Record of Decision
Operable Unit 3 – Marsh & River Sediment
Horseshoe Road and Atlantic Resources Sites
Sayreville, New Jersey

RECORD OF DECISION

Operable Unit 3 - Marsh and River Sediment
Horseshoe Road and Atlantic Resources Corporation Sites,
Sayreville Township, Middlesex County, New Jersey

Marsh Alternatives - Figure 4

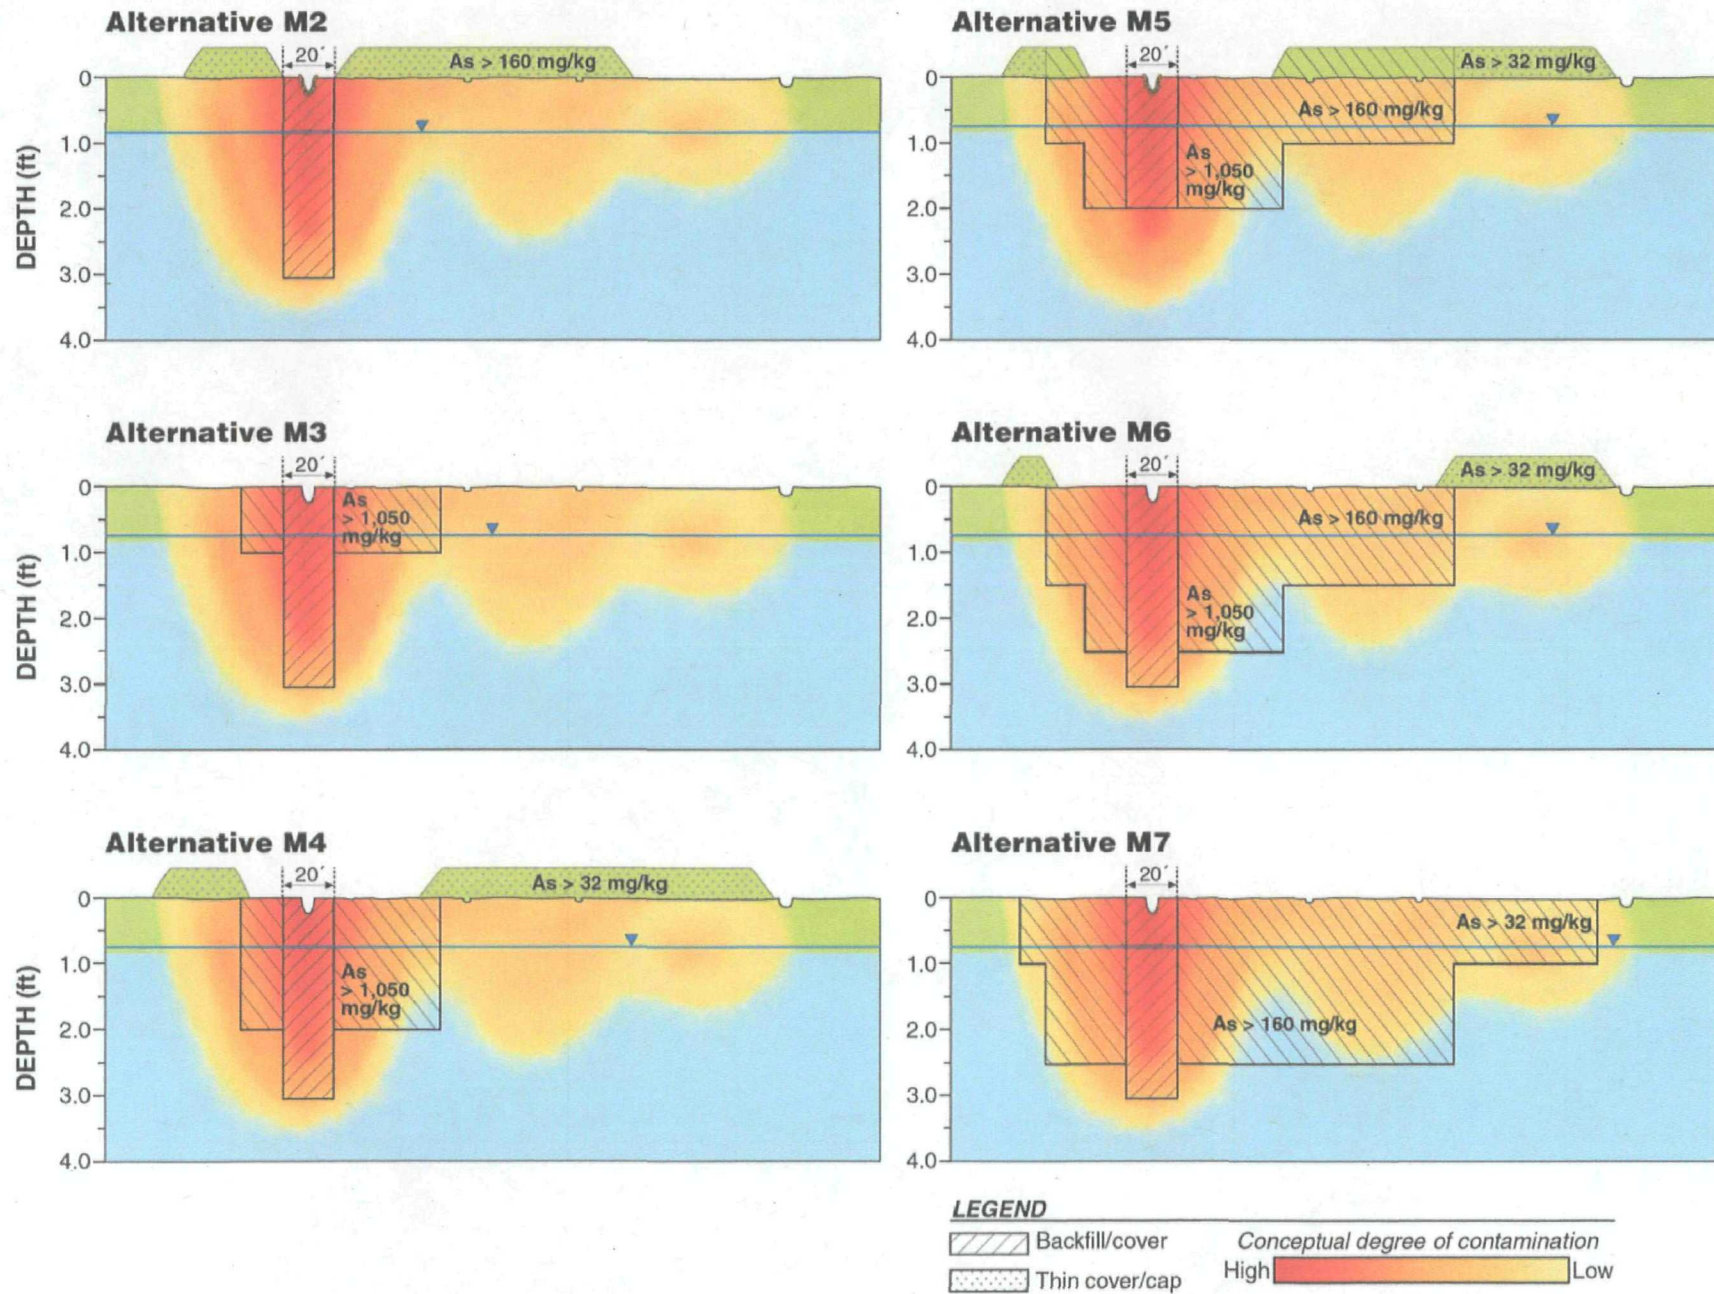
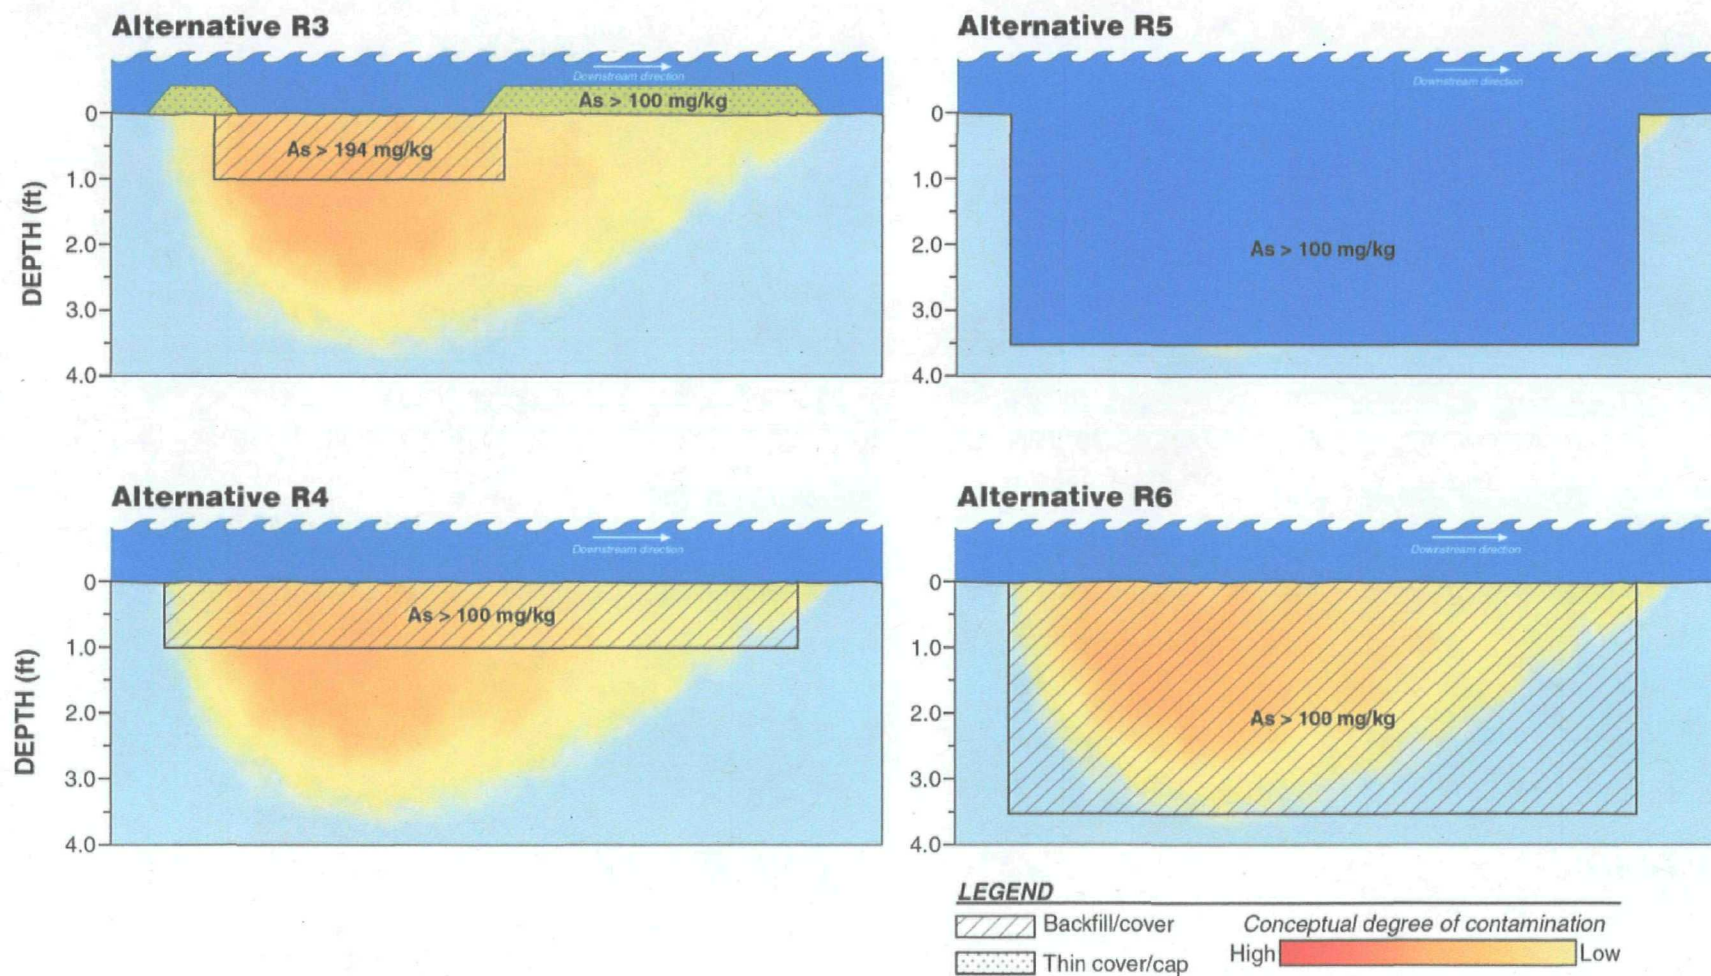
Comment #15: *A representative of Edison Wetlands Association asked why there isn't any horizontal scale to the cross-sectional views (figures 4 and 5), and why there is no trace line on the map view to indicate where the cross-sectional view is from.*

EPA Response - Figures 4 and 5 are conceptual models depicting how the contamination would be addressed in each alternative. These views do not accurately depict any one cross-section of the site but instead illustrate the various zones and how the alternatives will address them in a simplified format to make it readable. The horizontal scale is not relevant because it would differ depending on the area of the site you looked at, and likewise drawing a trace on the map would indicate that this is a detailed accurate representation of the cross-section defined by that line, which these figures are not.
